Rundschreiben: Gruppe: Motor - No. 3 Seite 2 17.08.1942

Betrifft: Abdichtung Nockenwellenbohrung hinten.

Re. Rear camshaft seal.

Skizze 1

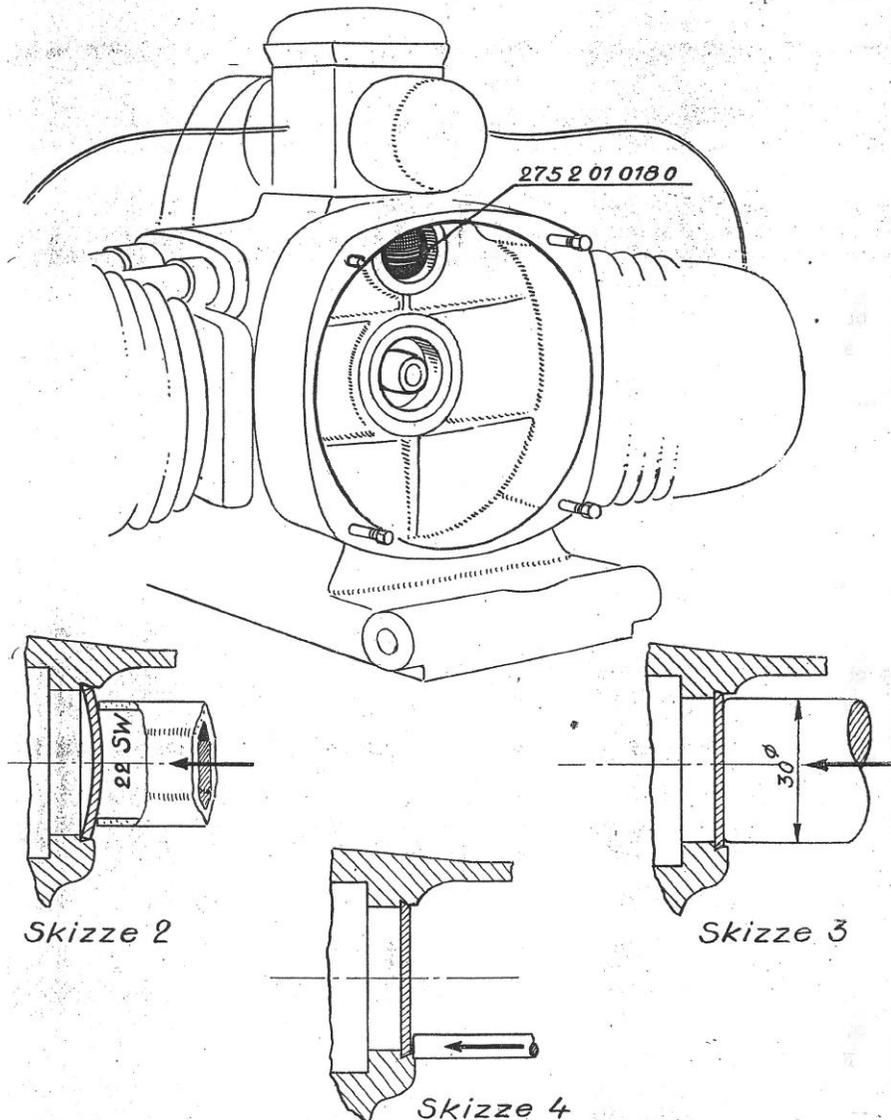
Bei diesem harmlosen Austausch eines Deckels wird dann richtig hingelangt. Da scheint man einem Lehrling bei BMW eine Aufgabe gegeben zu haben.

Zeichne mal was und dann auch noch falsch.

Der Deckel ist gewölbt und seine Außenkanten sind schräg, damit er sich schön einspannen kann.

Der Deckel wird nun flach eingeschlagen, obwohl auf Seite 1 steht das dies auf keinen Fall sein darf.

Hier wird dann auch noch gezeigt wie das Verstemmen zu geschehen hat.

Das Personal bei BMW in 1943 schien wenig Ahnung davon zu haben, worüber es überhaupt schrieb.

In this harmless exchange of a lid they mess it totally up.

Looks like they have given an apprentice this task at BMW.

Draw something and then wrong.

The lid is arched and its outer edges are sloping, so it can be nicely clamped.

The lid is now flat, although on page 1 this is not allowed to be.

Here is also shown how the caulking has to happen.

The staff at BMW in 1943 seems to have little idea of what they were writing about.
